Subject: McGuire Nuclear Station  
Response to Questions Concerning  
Fire Suppression Pump 'C'

In response to your questions of September 10, 1985, the following information is provided:

MCGUIRE NUCLEAR STATION  
 FIRE PUMP POWER SOURCES  
 DWN: JAK DATE: 10/8/84

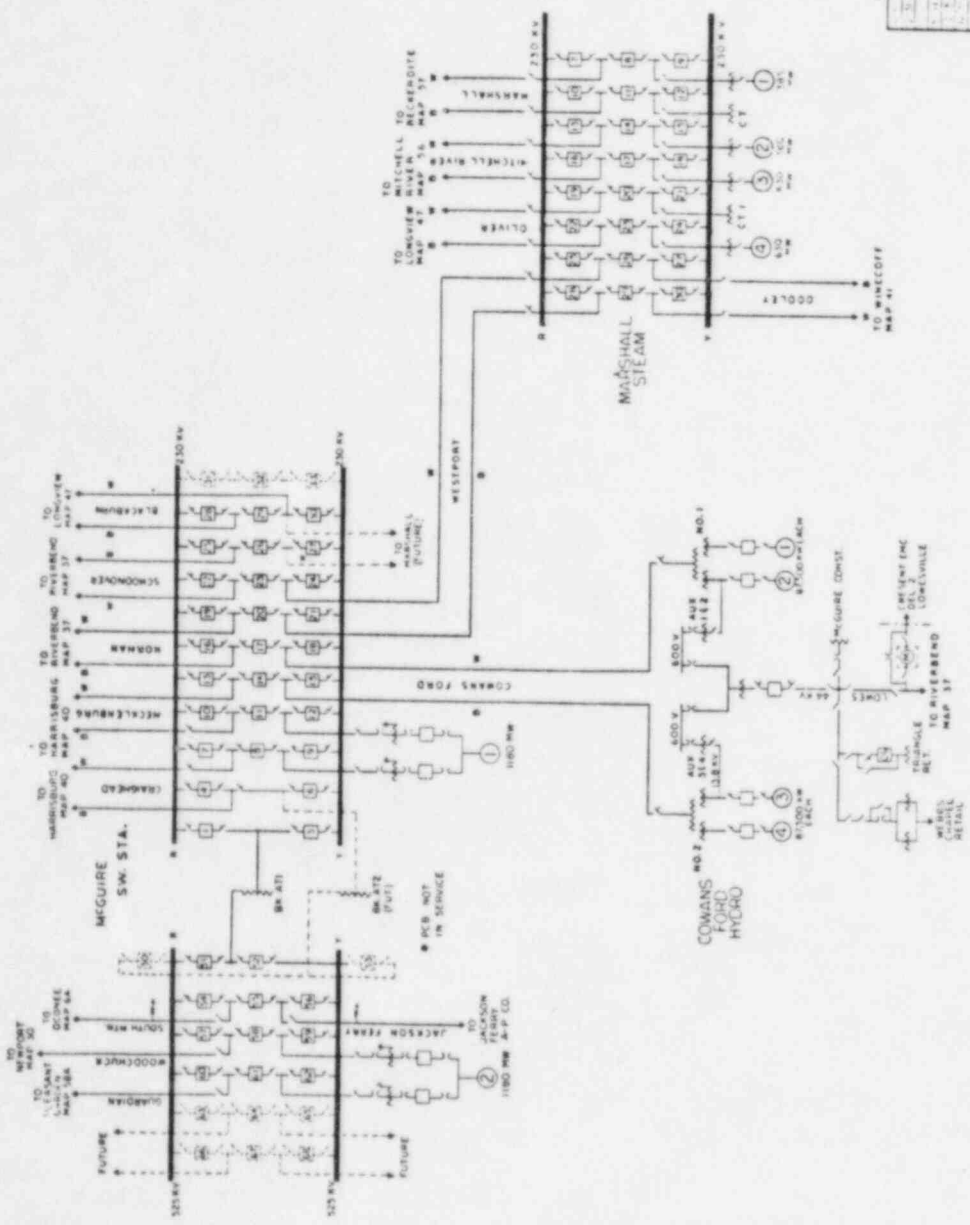
2. For fire suppression pump 'C', is the substation part of the grid or can it be separated from it?

Fire Suppression Pump C receives power from a 44KV substation fed from Riverbend Steam Plant Switchyard. There is no direct connection between the McGuire Switchyard and the 44KV System at Riverbend. The McGuire 525KV Switchyard has no direct tie to Riverbend, while the 230KV Switchyard is connected to Riverbend via the Schoonover and Norman Lines (see attached). At Riverbend, Units 6 and 7 feed the 230KV Switchyard through step-up transformers 6B and 7B.

The 44KV Switchyard is fed from the 100KV Switchyard through a tertiary winding on the step-up transformer for Units 1, 2, and 3 or through tie lines such as Mountain Island.

Under normal plant conditions, there is no tie between the 230KV Switchyard and the 44KV Switchyard at Riverbend. Units 6 and 7 have the capability to be aligned to the 100KV yard through alternate step-up transformers 6A and 7A; however, if this alignment is used, breakers to the 230KV Switchyard are opened and still no direct connection exists between the 230KV Switchyard and the 44KV Switchyard.

This isolation allows a total blackout of the McGuire Switchyard for any reason-fault, natural disaster, equipment failure, etc. to occur with no consequences to the 44KV feeder to Fire Suppression Pump C. Therefore, for any localized blackout situation at McGuire which would cause the loss of Fire Suppression Pumps A and B, Fire Suppression Pump C would still be available for service.
